CITY OF CODY
PLANNING, ZONING AND ADJUSTMENT BOARD
TUESDAY, JULY 24, 2018
CITY HALL COUNCIL CHAMBERS @ 12:00 NOON

**CITY OF CODY
PLANNING, ZONING AND ADJUSTMENT BOARD
STAFF REPORT**

MEETING DATE:	JULY 24, 2018	TYPE OF ACTION NEEDED	
AGENDA ITEM:		P&Z BOARD APPROVAL:	
SUBJECT:	12 TH STREET SUBDIVISION FOR THE WAY WEST LLC. SUB 2018-02.	RECOMMENDATION TO COUNCIL:	X
PREPARED BY:	TODD STOWELL, CITY PLANNER	DISCUSSION ONLY:

PRELIMINARY PLAT SHEET 1 OF 2

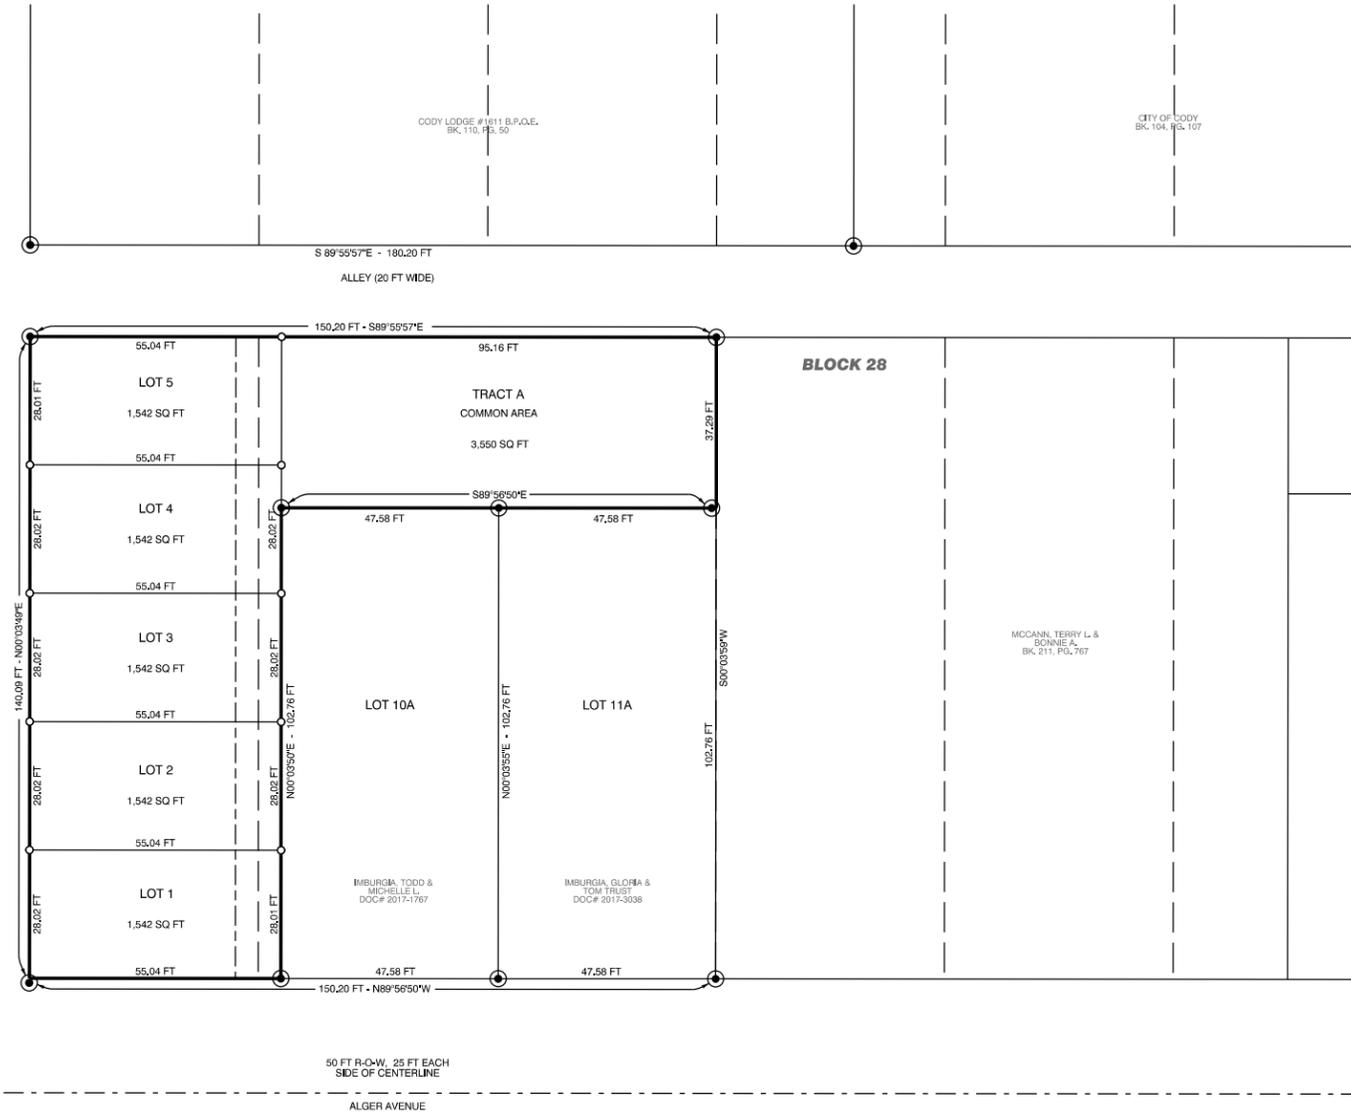
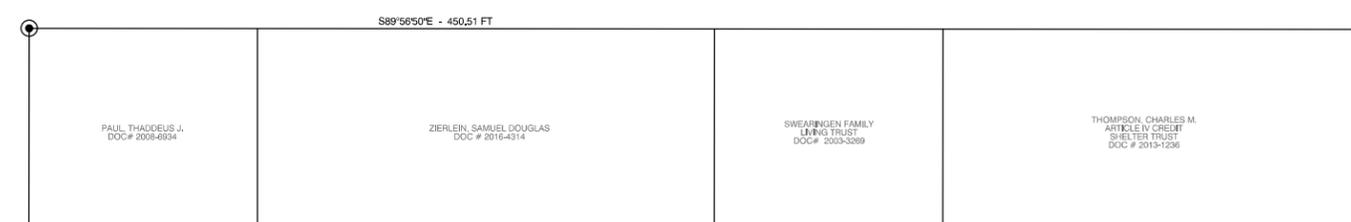
Comment: The applicant requests a variance to this requirement. It is noted that a utility easement and pedestrian access will be available on the back side of the lots. Due to the characteristics of the subdivision and garbage collection in the alley on the north side of the subdivision there is no need for a drivable alley along the back of the new lots.

Comment: The applicant proposes to serve all five lots from individual water taps in the main line in Alger Avenue. While the concept of such a layout is found in the residential infill subdivision regulations, this subdivision does not fall within that category because it is in a commercial zone. As such, the layout would require a variance to the water main standard because the main does not extend to the property line of each lot.

- I. Grant the variances requested (no alleys, no water main extension, and lot frontages of less than 50 feet);
- II. Allow up to one year from city council approval to record the final plat;

**UTILITY SERVICE PLAN
SHEET 2 OF 2**

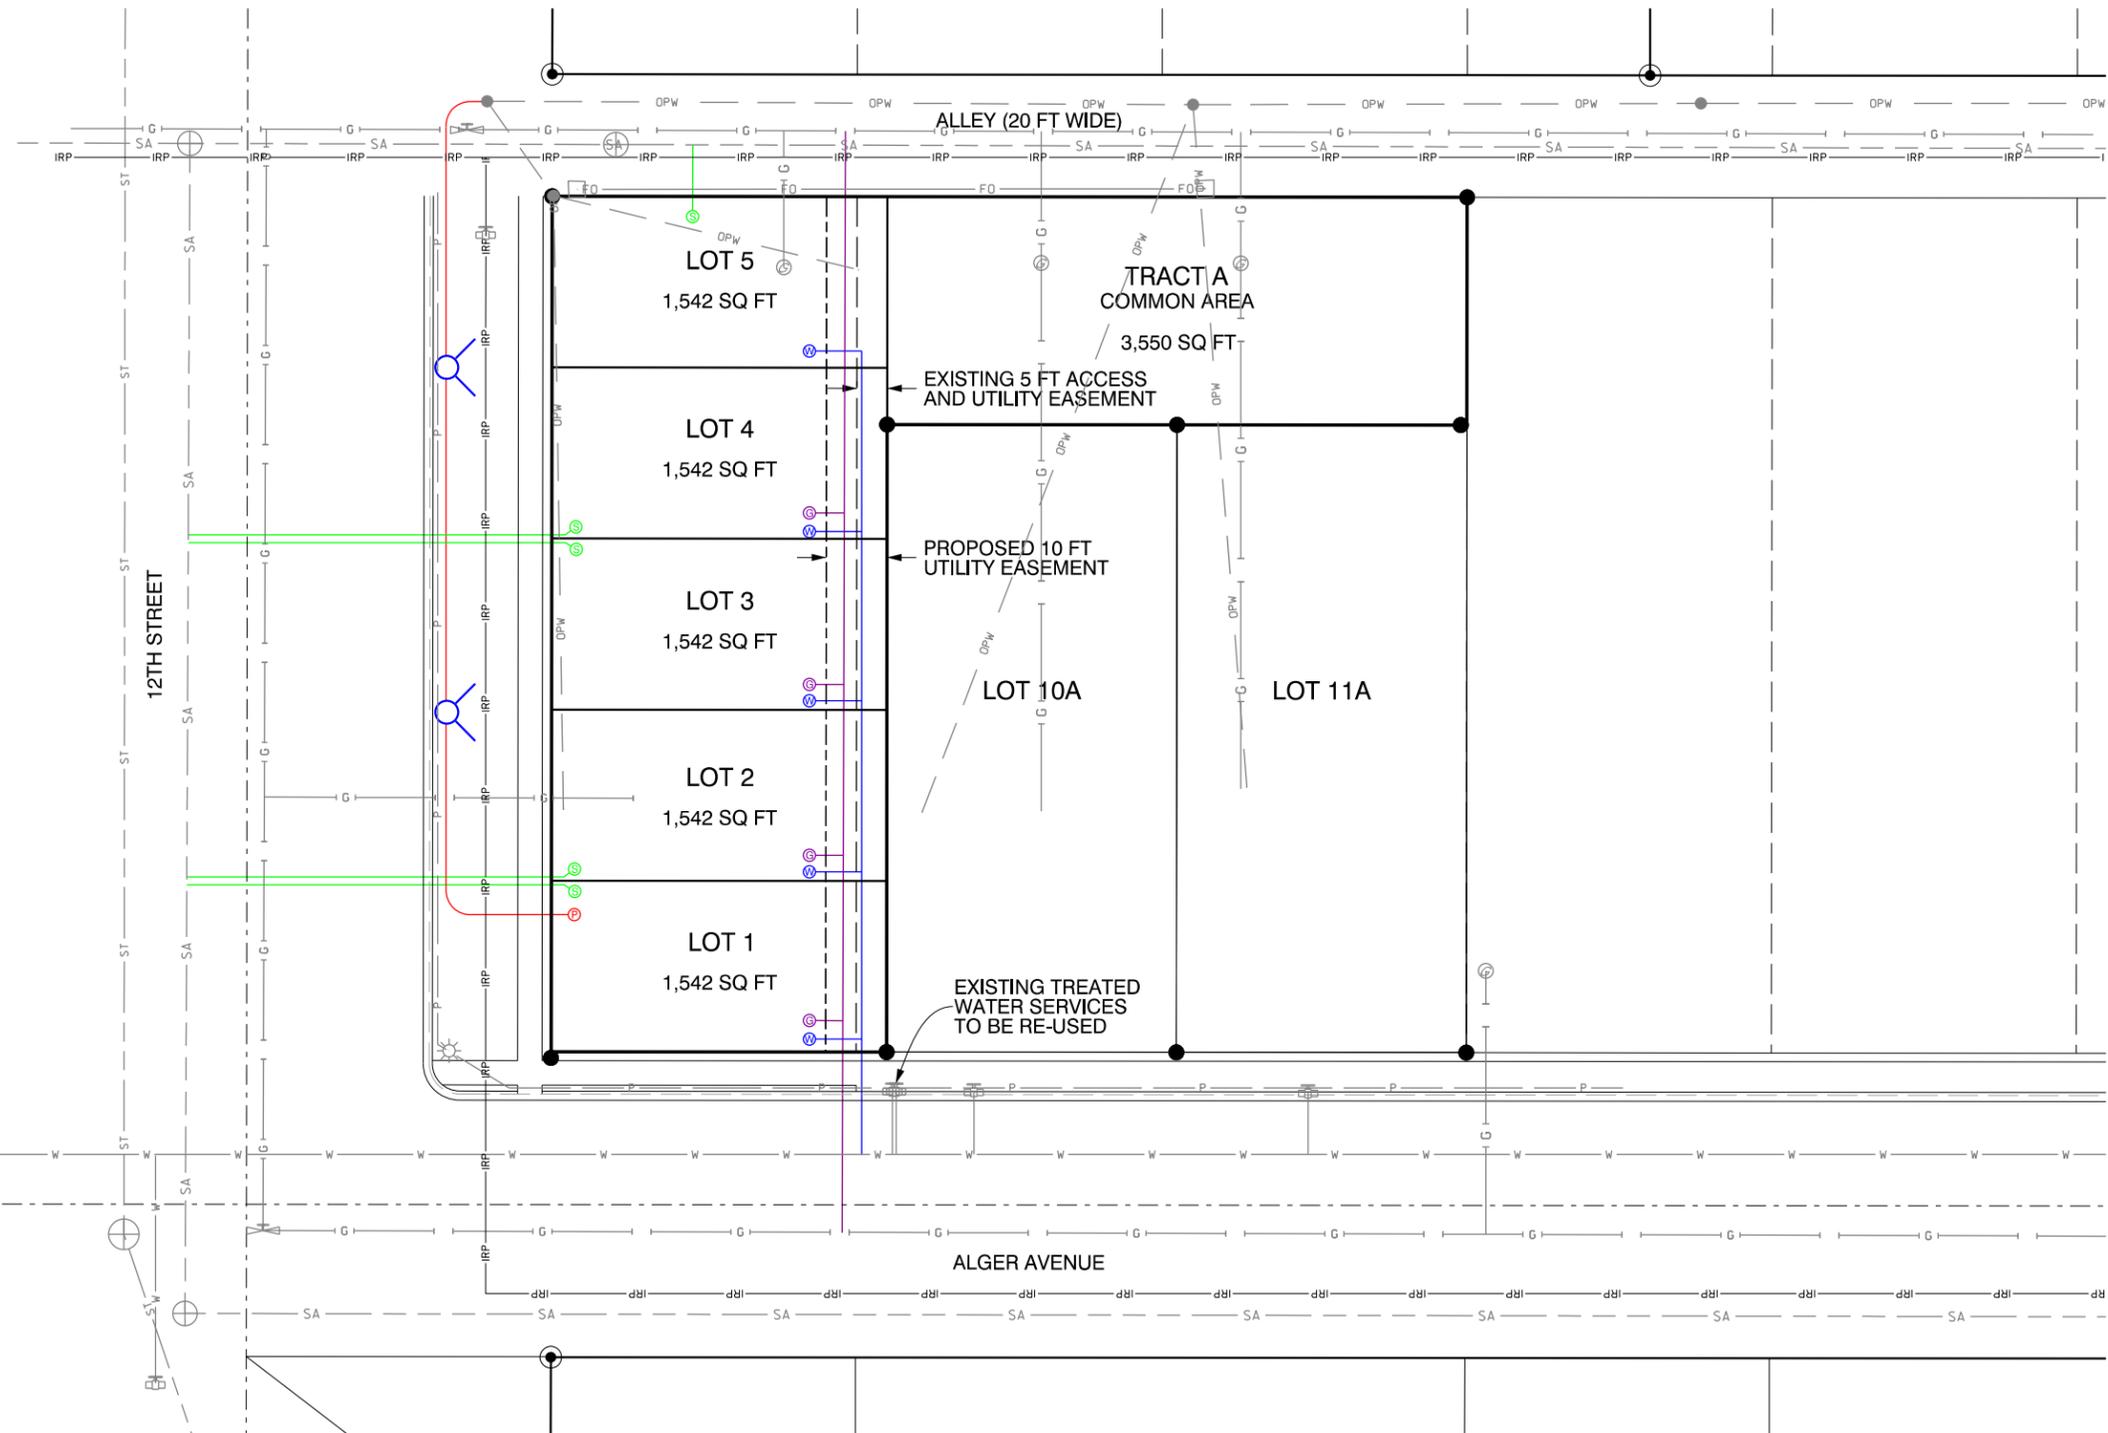
Power. Electrical service is available near the northwest corner of the property. The plan is to install a transformer on the overhead pole, and have power run as shown on the utility plan. The cost estimate for the city portion of the work has been sent to the applicant and will need to be paid prior to the mayor signing the final plat.

Cable/TV/Internet. The utility plan indicates phone and cable will be run in the same trench as the gas line in the back of the lot. We have not yet received verification from the utility providers that this is acceptable to them. Verification from the utility providers is needed.

Natural Gas: Natural gas is proposed to be run from the alley along the back of the lots.

5. The utility service plan must be approved by all utility providers, as evidenced by either their approval signatures on the plan, or written letters, prior to the mayor signing the final plat. At least one telecommunication utility must be provided to each of the lots.

FINAL PLAT

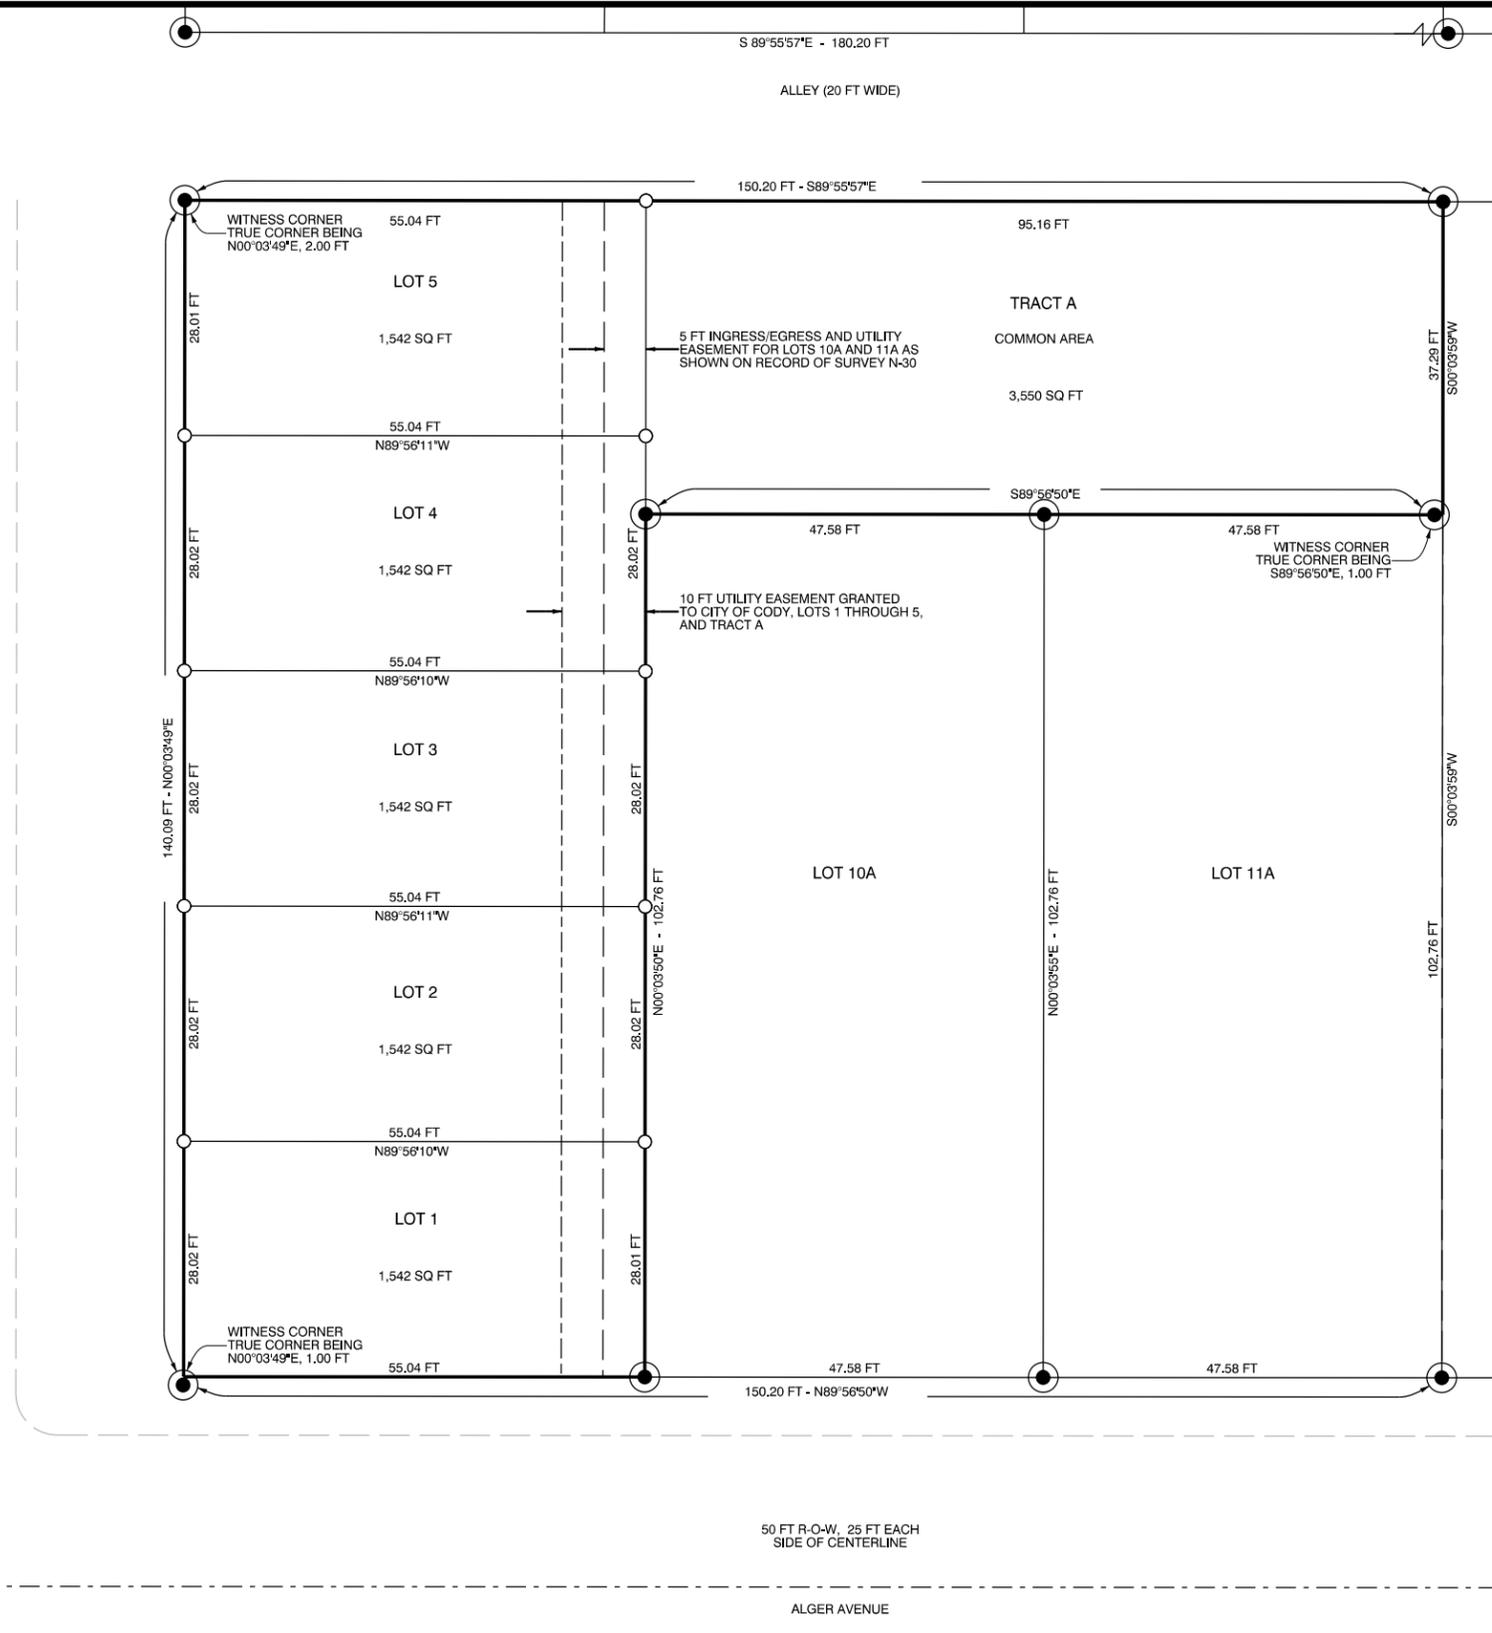
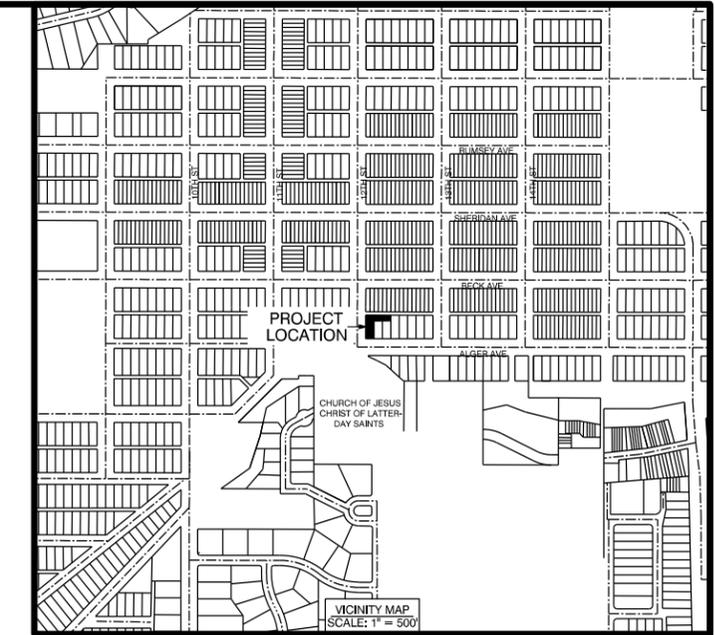
In addition, the plat should provide more guidance than it does on the common area. At a minimum, the area must be clearly dedicated as common area in the owner's certificate.

2. Add language to the owner's certificate dedicating Tract A as common area.
 3. Note 6 on the final plat can be removed, as the brass caps will be set before the final plat is recorded. Change the symbols on the final plat accordingly.

4. Add additional leaders and/or modify the note in Tract A to clearly show that the existing ingress/egress easement encumbers all of Tract A as well.
